Subject: Duke Energy Corporation (Duke)  
McGuire Nuclear Station Units 1 and 2  
Docket Numbers 50-369 and 50-370  
Technical Specifications Amendment  
Request for Additional Information (RAI); TS 3.7.15 -  
Spent Fuel Assembly Storage, and TS 4.3 - Fuel  
Storage

**Responses to Nuclear Regulatory Commission Request for  
Additional Information Related to McGuire Nuclear Stations's  
License Amendment Request for No-Boraflex Credit**

Figure 17.1. Comparison of McGuire Discharge Fuel "Measured minus Predicted" Burnup Distribution with Normal Distribution Sample

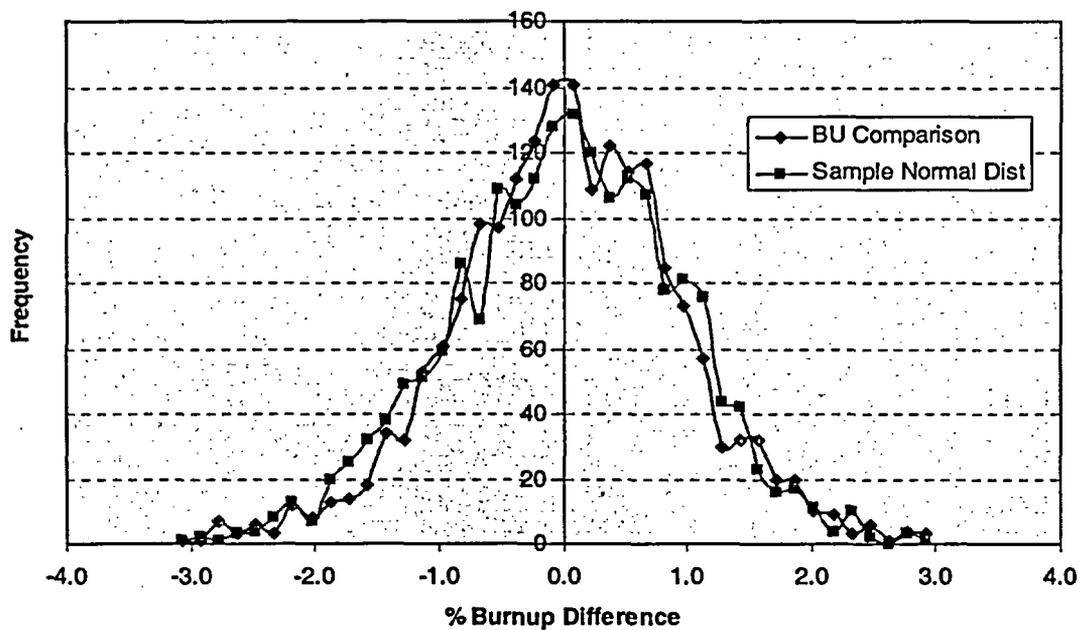
In Attachment 6, Section 8.2, the licensee stated that when predicted and measured burnup data was compared, the maximum individual assembly error observed was about 4.0 percent. The licensee then stated that "[w]hen an array of fuel assemblies large enough to affect system reactivity is evaluated for the McGuire SFP Region 2, and the distribution of predicted-to-measured burnup differences is accounted for, the maximum system reactivity increase observed is [approximately] 0.00125 delta-k." Please provide the following:

- a. An explanation of whether the determination of the maximum system reactivity increase is based on the maximum individual assembly error observed (about 4.0 percent) or on a distribution of observed predicted-to-measured burnup differences.
- b. If the maximum individual assembly error observed was used, provide a detailed explanation justifying why this error will remain bounding for future spent assemblies.
- c. If a distribution of observed predicted-to-measured burnup differences was used, provide a detailed description of how the distribution used to arrive at the 0.00125 delta-k value was selected and an explanation of why this distribution is bounding for all potential spent fuel loading configurations.

The burnup measurement uncertainty of  $\pm 0.00125 \Delta k$  is based on an evaluation that considered the distribution of predicted-to-measured burnup differences, rather than the worst-case individual assembly error. This approach was taken because it has been observed that, for moderate reactivity differences

To quantify a bounding burnup measurement uncertainty in this manner, measured burnups (from in-core detector measurements) and predicted burnups (from SIMULATE-3 core follow calculations) were compiled for the discharge fuel assemblies from McGuire's entire reactor operation history to date. This totaled over 1900 fuel assemblies. The percent differences between the measured and predicted burnups were computed, and a sorted distribution of these differences was made. This distribution was then compared with a randomly-generated normal distribution of the same sample size, with the same standard deviation. These distributions are plotted together in Figure 17.1. Note that the distribution of burnup measurement errors approximates a normal distribution rather well. The skewness, which measures the symmetry of the distribution, is very close to the desired zero. The kurtosis of the measurement error distribution is somewhat higher than the normal zero value, which indicates that the distribution is more peaked (narrower) than a true normal distribution.

This distribution of predicted versus measured burnup errors was used to quantify the largest conceivable average burnup error for various clustered arrays of fuel assemblies, which were put together by randomly selecting assemblies (with replacement) from the large McGuire core-follow inventory of discharge fuel. The random-selection process was carried out with storage arrays ranging from a 3x3 to a 12x12 array. Over 1900 random samples were taken for each of these arrays. For each of these samples, the "average" burnup measurement error was determined by taking the average of the individual burnup errors within the pertinent array. The resulting "average" burnup measurement errors were then sorted, and the highest "average" error for each array size was conservatively taken for specific analysis of the maximum conceivable burnup measurement uncertainty. Table 17.1 documents these maximum "average" burnup errors for each of the array sizes selected.

The Table 17.1 results show that the largest  $k_{eff}$  increase (0.00125  $\Delta k$ ) occurs with a 12x12 array of fuel, which has a worst-case average burnup error of 0.32%. This maximum burnup measurement uncertainty is judged to be appropriate and bounding for the following reasons:

Figure 18.1. Comparison of McGuire Discharge Fuel Axial Profile  $\Delta k$  (Actual Profile minus “Average” Profile) Error Distribution with Normal Distribution Sample

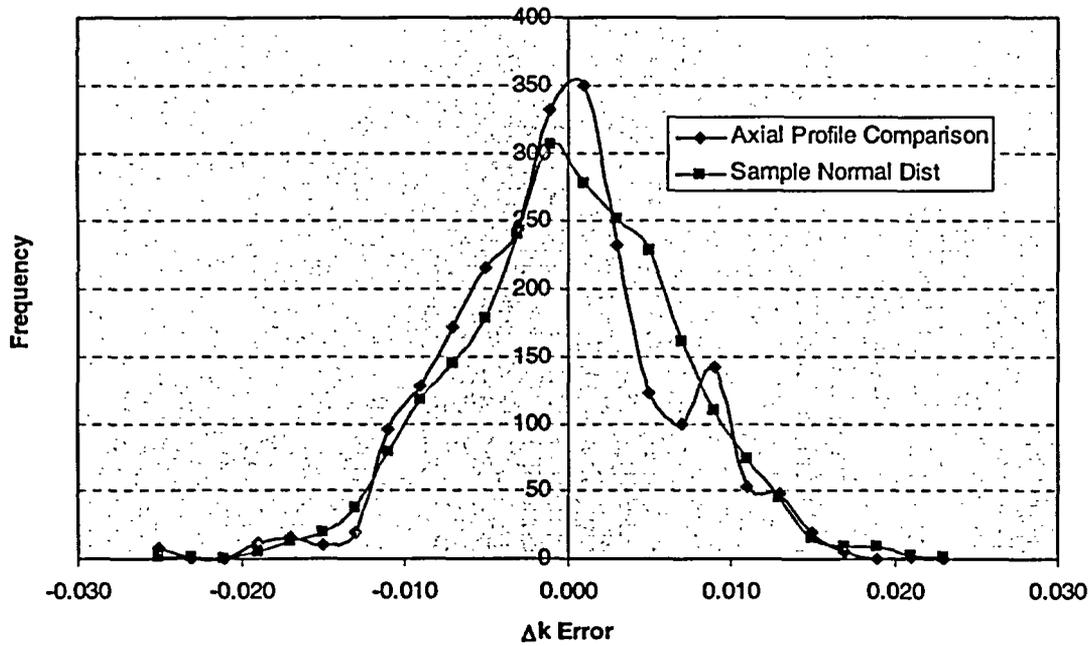
In Attachment 6, Section 8.2, the licensee stated that axial profile  $k_{eff}$  errors compare rather well with a normal distribution. Additionally, the licensee identified that the largest individual assembly axial profile error calculated is +0.030 delta-k. However, the licensee determined the bounding axial profile uncertainty by considering a group of fuel assemblies large enough to affect system reactivity and taking into account the distributions of axial profile  $k_{eff}$  errors within that group. The licensee determined that the bounding axial profile uncertainty is  $\pm 0.00305$  delta-k. Please provide detailed information on the methodology that was used to select the distribution used to calculate the axial profile uncertainty and why this distribution is bounding for all potential spent fuel loading configurations.

To quantify the axial profile uncertainty, the same statistical approach employed for the burnup measurement uncertainty - evaluating worst-case "average" reactivity errors for different array sizes - was used. The first step in this process was to gather the actual McGuire core follow axial history profiles, which had been used to generate the average (estimated) axial profiles for each McGuire fuel type and burnup range. These actual profiles were imported into individual SIMULATE-3 cases that computed  $k_{eff}$ s for all of these end-of-cycle core follow data points (McGuire 1 Cycles 1 through 15, and McGuire 2 Cycles 1 through 14). These same cases were then re-run using the pertinent average axial profiles from Attachment 6 of the LAR, Tables 10 through 16. After filtering the final discharge fuel data from these cases, the axial profile  $\Delta k$  differences were compared with a sample normal distribution with the same standard deviation. These distributions are shown in Figure 18.1. Note that, as with the measured burnup errors in Figure 17.1, the axial profile  $\Delta k$  errors have a slightly more peaked distribution than the sample normal distribution.

As with the burnup measurement uncertainty, the distribution of individual axial profile  $\Delta k$  errors was used to determine the largest feasible SFP system axial profile  $\Delta k$  uncertainty. Various arrays of symmetric assembly quartets were put together by randomly selecting assemblies (with replacement) from the large McGuire core-follow inventory. The random selection process was carried out with storage arrays ranging from a 2x2(x4) to a 6x6(x4) array. Over 2300 random samples were taken for each of these arrays. For each of these samples, the "average" axial profile  $\Delta k$  error was determined by taking the average of the individual  $\Delta k$  errors within the pertinent array. The resulting "average"  $\Delta k$  errors were then sorted, and the highest "average" error for each array size was conservatively taken for specific analysis of the maximum feasible system axial profile uncertainty. Table 18.1 documents these maximum "average"  $\Delta k$  errors for each of the array sizes selected. Note that for each of these maximum "average"  $\Delta k$  errors, a single assembly from the McGuire core follow database was selected with the matching  $\Delta k$  error for that particular array size.

For each case listed in Table 18.1 the center array within the total 12x12 system matrix used the actual axial history profiles from the core follow data of the chosen fuel assembly for that particular array size. Any surrounding assemblies making up the balance of the 12x12 system matrix used the pertinent "average" axial profiles (from Tables 10 through 16 in Attachment 6) for the chosen fuel assembly. The Table 18.1 results show that the largest system  $k_{eff}$  increase occurs with a 6x6(x4) array of fuel, which yields a worst-case average axial profile error of 0.00305  $\Delta k$ . This maximum axial profile uncertainty is judged to be bounding for the following reasons:
